Discussion of DNR Comments on Changes to Water Supply Infrastructure and Environmental Impacts with a Hypothetical Low Water Demand

PREPARED FOR: Wisconsin Department of Natural Resources

PREPARED BY: CH2M HILL
Robert Nauta/AECOM
John Jansen/Leggette, Brashears and Graham

DATE: March 24, 2014

Figure 16

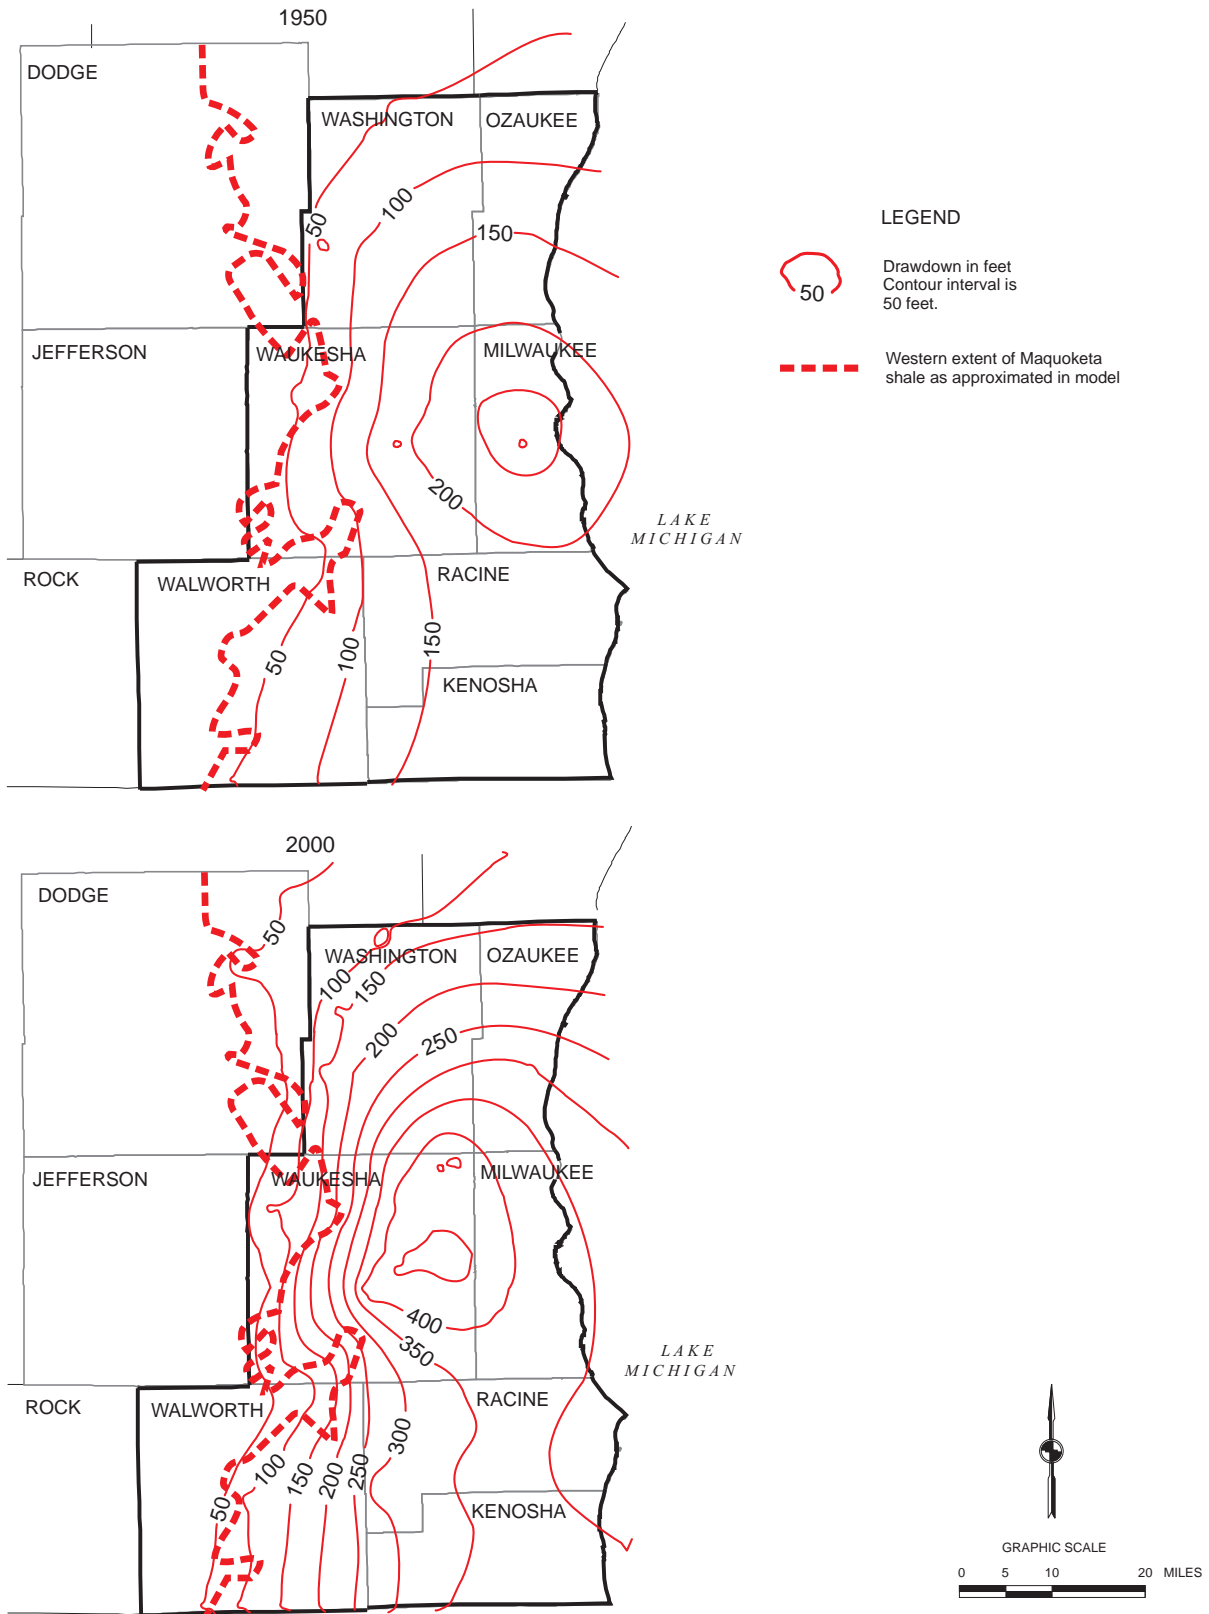
- In Table 2 for Alternative 5 – the memo indicates at the 2 MGD pumping scenario the drawdown is greater than 150 ft. The modeled drawdown for the 2 MGD scenario is actually reported to be 40 feet in Exhibit 11-34 of volume 2 of the current application. In addition, the modeled drawdown at 10.5 MGD is reported in the application to be slightly more than 150 ft. Thus, [it may not be] a reasonable assumption that the modeled drawdown for an 8.5 MGD withdrawal would be 150 ft or greater. Please correct the memo to address these concerns.*

Response: The drawdown shown in Exhibit 11-34 of Volume 2 of the Application is the change in drawdown from recent baseline conditions. It does not compare the drawdown to predevelopment conditions, which is the basis for designation as a groundwater management area under Wisconsin Administrative Code Chapter NR 820. The recent baseline condition is approximately 100 feet below predevelopment conditions, as reflected in the Southeastern Wisconsin Regional Planning Commission’s (SERWPC’s) A Regional Water Supply Plan for Southeastern Wisconsin (SEWRPC, 2010) (See Figures 16, 17, and 18 included as Attachment A for convenience). Consequently, withdrawal of 2 million gallons per day (mgd) results in an additional 40 feet of drawdown or a total drawdown of approximately 150 feet compared to predevelopment conditions. Because the 10.5 mgd analysis reported a drawdown of 150 feet from recent conditions or a total of approximately 250 feet from predevelopment conditions, a hypothetical average day demand (ADD) of 8.5 mgd will easily have a drawdown of 150 feet or greater compared to predevelopment conditions. No change to the memo is necessary.
